From: Aselda.Thompson@shell.com
To: [Vergeront, Julie](#); [Morales, Javier](#)
Cc: [Devan.Bagley@shell.com](#)
Subject: RE: Shell Puget Sound Refinery
Date: Tuesday, April 28, 2020 8:11:23 AM
Attachments: [2020 04-22 RMP Resubmittal.pdf](#)

From: Vergeront, Julie <Vergeront.Julie@epa.gov>
Sent: Thursday, February 6, 2020 5:51 PM
To: Thompson, Aselda J SHLOIL-LSPT/EE <Aselda.Thompson@shell.com>
Cc: Morales, Javier <Morales.Javier@epa.gov>
Subject: Shell Puget Sound Refinery

I am writing up to follow up on our meeting on Tuesday, January 28, 2021 in Seattle, to discuss the allegations in EPA's October 31, 2019 letter. It was a productive discussion.

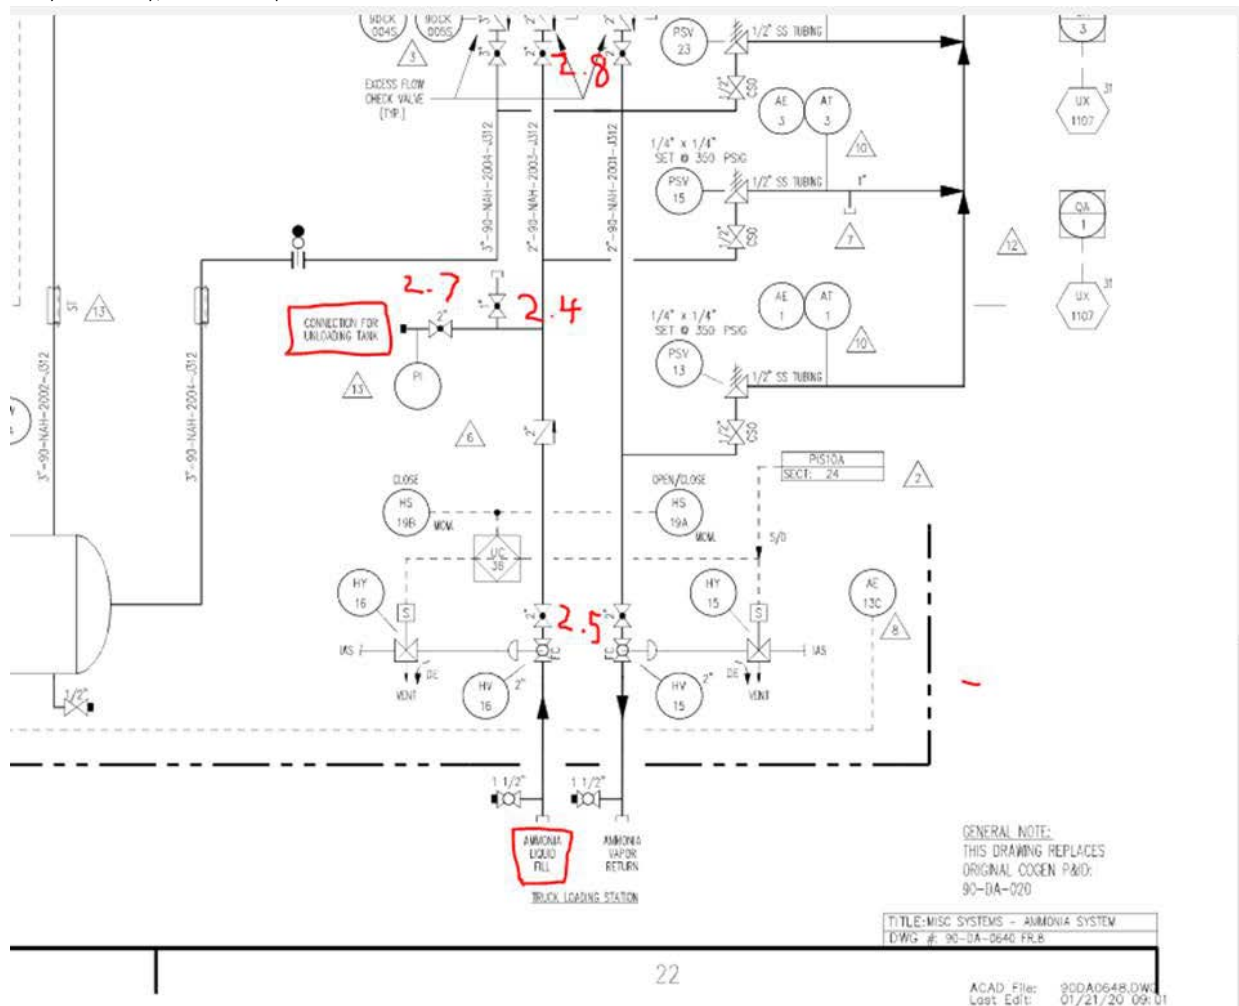
Concern 3: *Unfortunately, neither Javier nor I have good notes regarding why Shell did not make any changes in response to Concerns 3b and 3c. Please either provide a brief written explanation or call me to discuss.*

Concern 3: Unfortunately, neither Javier nor I have good notes regarding why Shell did not make any changes in response to Concerns 3b and 3c. Please either provide a brief written explanation or call me to discuss.

Concern 3(b)- We explained during our meeting that the procedure (Bates labeled PSRRMP0600-0605) is clear as follows: Step 2.7 refers to the “unloading line” which is identified on the P&ID (Bates labeled PSRRMP0620) and the block valve mentioned in step 2.7 is the block valve next to where the operator connected the nitrogen hose in step 2.2. It also states that the operator is “to pressurize the line with nitrogen” in step 2.7, which also makes it clear that they are not opening the valve indicated in step 2.8 used to pressurize the ammonia tank. Step 2.8 mentions a 2” valve on the ammonia fill line, which line is also labeled on the P&ID as a separate line. Step 2.8 indicates the intent of this step is to pressurize the ammonia tank, which further clarifies to the operator which valve should be opened. We also mentioned that the N2 hose connection is incapable of connecting to the ammonia liquid fill line because the connections do not match. So, the only location where the operator

can connect the N2 hose is the “unloading line.”

For your clarity, see the steps noted below.

AOC 3(c) - In the meeting, we explained that the 1” vent on the unloading line is distinct from the ammonia fill line (see P&ID above) and that it would be counterproductive to have an explicit step for the operator to verify that this 1” line is closed for the following reasons:

1. It is standard site policy to keep all bleeders/vents capped and plugged (two barriers) when not in use. As this 1” vent is not used in unloading, site policy dictates that it will remain closed and plugged.
2. As an additional safeguard to ensure that the 1” vent remains closed, if the vent is left open, ammonia would be leaking to the atmosphere and alarms would sound from the ammonia detectors in the area. Thus, the fact that ammonia analyzers are not alarming provides sufficient verification that the 1” vent is closed.
